DART SERVICE INSTRUCTION

TO AMEND INSTALLATION INSTRUCTIONS: IIN-D206-667 REV. C
REF. CANADIAN STC: SH01-5
REF. FAA STC: SR01304NY

DESIGN	<i>RA</i>	DART AEROSPACE LTD HAWKESBURY, ONTARIO, CANADA	
DRAWN	<i>RA</i>		
CHECKED	<i>IP</i>	DRAWING NO. DSI 9346	REV. H
MFG. APPR.	<i>N/A</i>	SHEET 2 OF 2	
APPROVED	<i>RA</i>	TITLE	SCALE
DE APPR.	<i>RA</i>	DEVIATION ON D206-667 & D407-667	NTS
DATE	08.06.16	COPYRIGHT © 2006 BY DART AEROSPACE LTD THIS DOCUMENT IS PRIVATE AND CONFIDENTIAL AND IS SUPPLIED ON THE EXPRESS CONDITION THAT IT IS NOT TO BE USED FOR ANY PURPOSE OR COPIED OR COMMUNICATED TO ANY OTHER PERSON WITHOUT WRITTEN PERMISSION FROM DART AEROSPACE LTD.

FIGURE 1 - INSTALLATION OF DART CROSSTUBES ON BHT/AAI SKIDTUBE

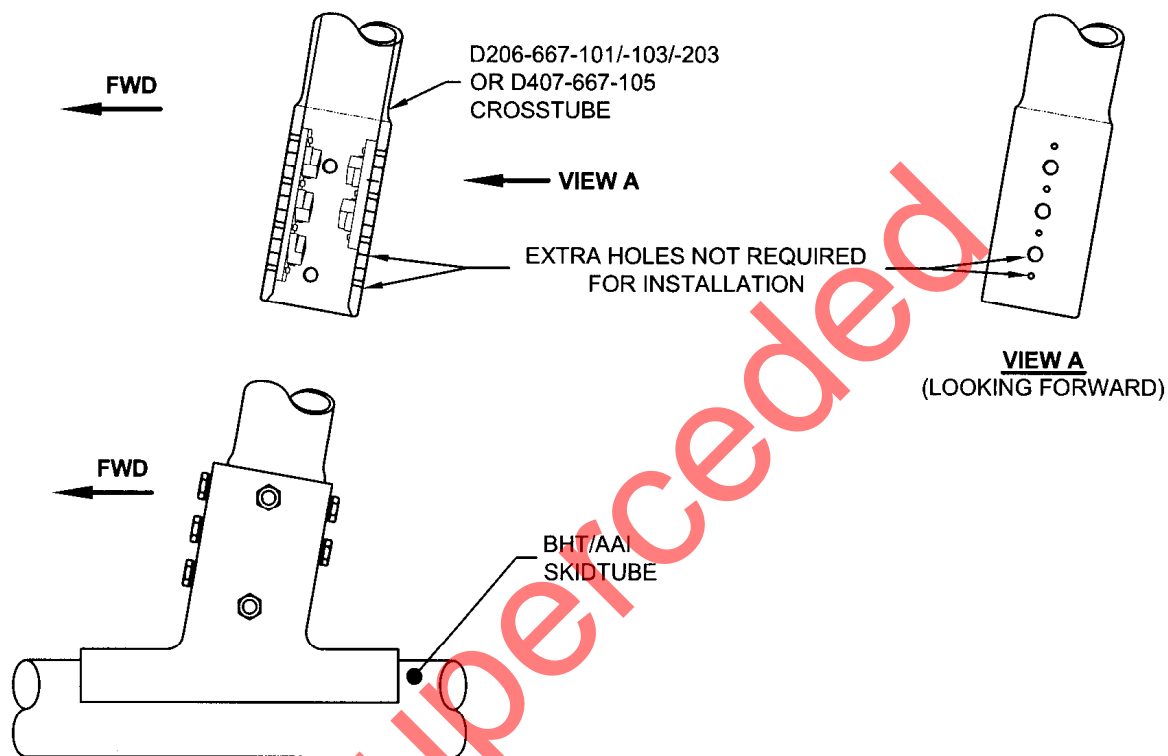
THE FOLLOWING D206-667-101/-103/-203 AND D407-667-105 CROSSTUBES HAVE EXTRA HOLES DRILLED ON THE AFT SIDE OF THE CUFFS. THIS HOLE IS NOT REQUIRED FOR INSTALLATION OF DART CROSSTUBES ONTO BHT/AAI SKIDTUBES AS SHOWN IN FIGURE 1.

CUSTOMERS RECEIVING CROSSTUBES AT CHG 002 PRIOR TO 06.08.08 SHOULD CONTACT DART FOR DISPOSITION IF INSTALLING THE DART CROSSTUBES ONTO BHT/AAI SKIDTUBES PER IIN-D206-667 REV. C.

CUSTOMERS RECEIVING CROSSTUBES AT CHG 002 PRIOR TO 06.08.08 TO BE INSTALLED WITH DART SKIDTUBES MAY FIND THAT THE SUPPORTS HAVE BEEN INSTALLED BACKWARDS. THE SUPPORTS SHOULD BE REMOVED AND RE-INSTALLED PER ICA-D206-667.
